**National Highways Planning Response (NHPR 21-09)
Formal Recommendation to an Application for Planning Permission**

Council's Reference: LCC/2021/0007

Location: Land north of the A674 Millennium Way, north east of M61 Junction 8

Proposal: Prior extraction of sand / gravel and subsequent restoration with inert engineering fill to facilitate a platform for employment development or agriculture with peripheral landscaping

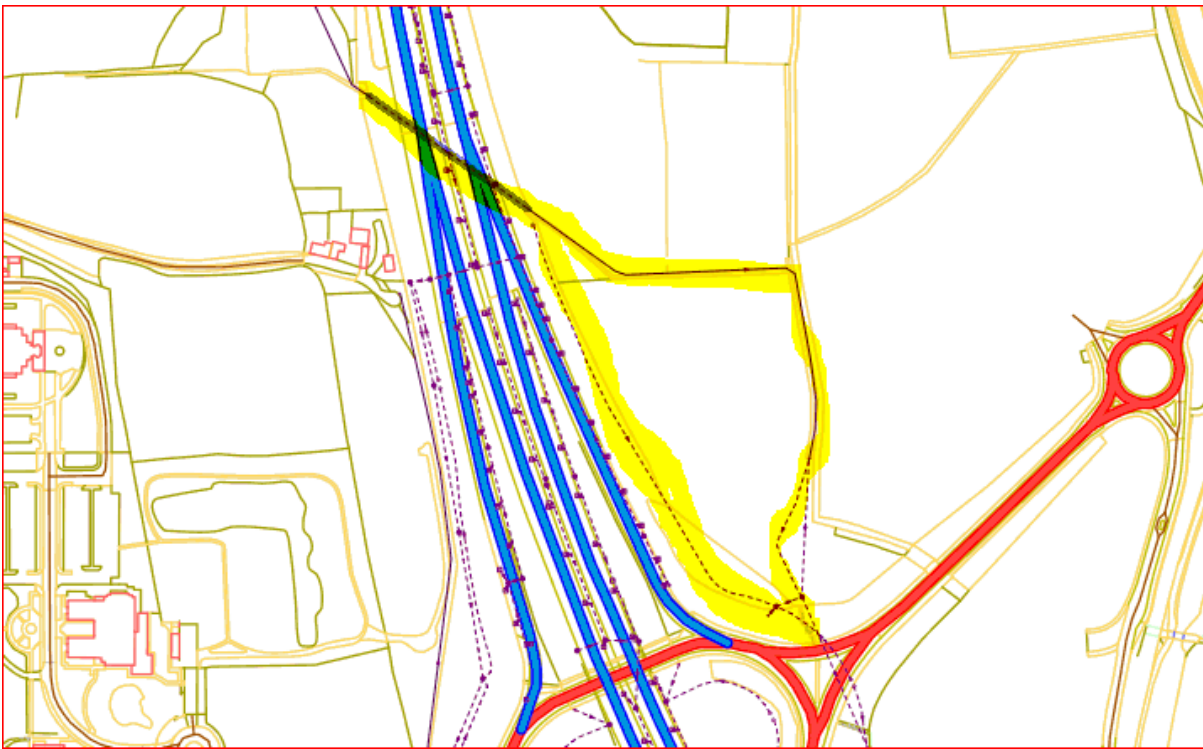
A motorway filter drain runs along the motorway boundary with this site at the foot of the motorway embankment., as shown in the drawing below. **Again, there will need to be a level of standoff agreed with National Highways from the excavation to ensure that this drain is not disturbed.**

Of note however is that there is a 1200mm diameter culvert that crosses under the M61 north of Junction 8 that discharges into one of the drainage ditches that crosses the excavation area. It would appear from the Supporting Statement that these drainage ditches downstream are to be diverted as part of the mineral extraction operations, **but the plans are not clear as to their new location, and so confirmation of their new location is needed along with a longitudinal profile to demonstrate that there is still sufficient a**

fall to ensure that there will be no risk to the motorway culvert. A maintenance regime for this channel should also be provided.

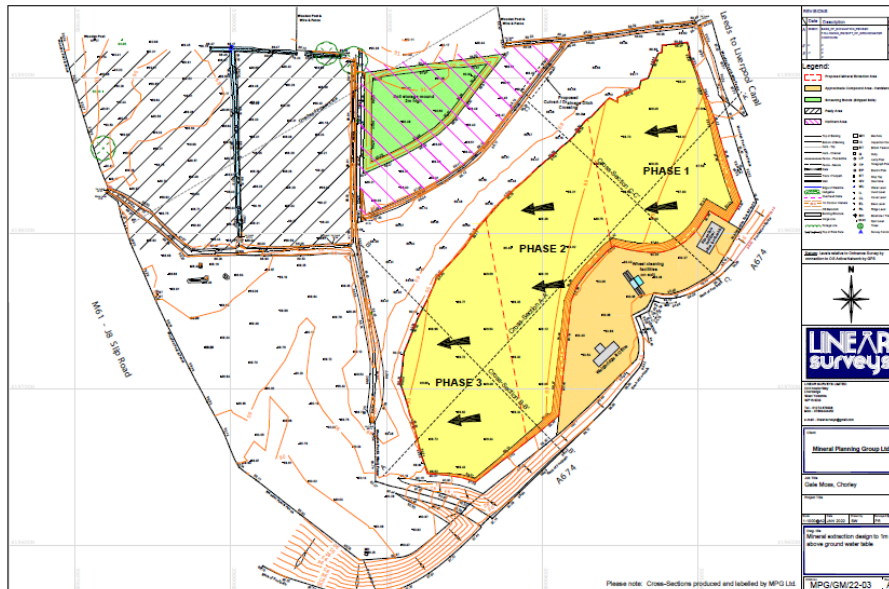
- Drawing reference MPG/GM/22-03, submitted with the planning application originally, shows the extent of mineral extraction across the site. This drawing, which is also included in the Analysis of Slope Stability and the Supporting Statement, shows the proposed extraction is well away from the M61.

However, other drawings included as part of the Plan submission such as MPG/GM/DEC20-04 and MPG/GM/DEC20-01 (attached for ease of reference) show the excavations to extend close to the M61 boundary.

Lancashire County Council (as the planning authority) have since confirmed to us that the physical extent of the development has been reduced from that proposed with the application originally, and is that shown in drawing reference MPG/GM/22-03 Rev A (extract copied below)

As no mineral extraction work will not be taking place close to the motorway boundary, we are satisfied that there is no need for any slope stability analysis.
